Access Compliance Report

Public Rights-of-Way

(Curb Ramps)

Intersection ID: 51443	Main Street: SHARON_RD	Cross Street: ASHLEY_PARK_LN	Location: W
ADA ID: E1126936D94F	Ramp Type: BlendTrans2	Initial Pass/Fail: Pass	Overall Compliance: No
Severity Score: 0.25			
Codes/Mitigation Info/Possible Solution		Field Measurements/Component Compliance

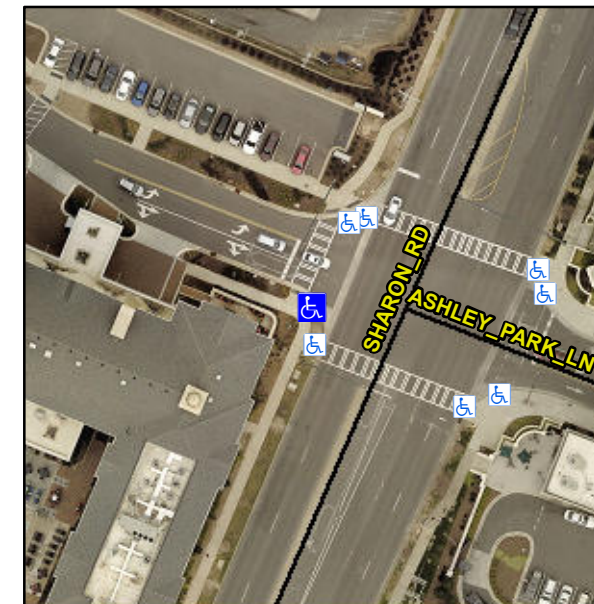
Not Found, R304.5.3

Compliance	Description	Data	Compliance	Description	Data
N/A	Ramp Length (in)	85.0	Yes	BlendTrans Slope (%)	2.9
Yes	Ramp Width (in)	84.0	No	BlendTrans XSlope (%)	2.6
Yes	Flare Type L	Curbed_NoWalkSurface	Yes	Flare Type R	Curbed_NoWalkSurface
N/A	Flare Slope LT (%)	N/A	N/A	Flare Slope RT (%)	N/A
N/A	Flare Traversable LT?	No	N/A	Flare Traversable RT?	No
N/A	Landing Length (in)	N/A	Yes	DWS Provided?	Yes
N/A	Landing Width (in)	N/A	Yes	DWS Contrast?	Yes
N/A	Landing Slope (%)	N/A	Yes	DWS Length (in)	24.0
N/A	Landing X Slope (%)	N/A	Yes	DWS Full Width?	Yes
N/A	Landing Curb? (Y/N)	No	Yes	DWS Offset (in)	1.5
N/A	Shared Landing?	No			
Yes	Gutter Ponding?	No	Yes	Gutter Slope (%)	0.3
Yes	Gutter Lip Ht (in)	0.0	Yes	Gutter X Slope (%)	1.5
N/A	Painted X Walk1?	Yes	N/A	Painted X Walk2?	N/A
	X Walk 1 Direction	To NE		X Walk 2 Direction	N/A
	X Walk 1 Width (in)	109.0		X Walk 2 Width (in)	N/A
	X Walk 1 Slope (%)	1.3		X Walk 2 Slope (%)	N/A

X Walk 1 X Slope (%)	0.5		X Walk 2 X Slope (%)	N/A
Yes	Ramp inside XWalk1?	Yes	N/A	Ramp inside XWalk2?	N/A
	Road Slope (%)	0.5		Clear Space?	Yes
	Road X Slope (%)	1.3	N/A	Clear Space to XWalk (in)	N/A
Yes	Any Obstructions?	No	Yes	Storm Grate/Utility Hazard?	No
	Obstruction Type			Storm Grate/Utility Type	
		N/A			N/A
			Yes	Surface Condition? (G/P)	Good
			No	Curb Slope (%)	9.9

Remove & Replace Curb Ramp With Two New Directional Ramps or Equivalent.
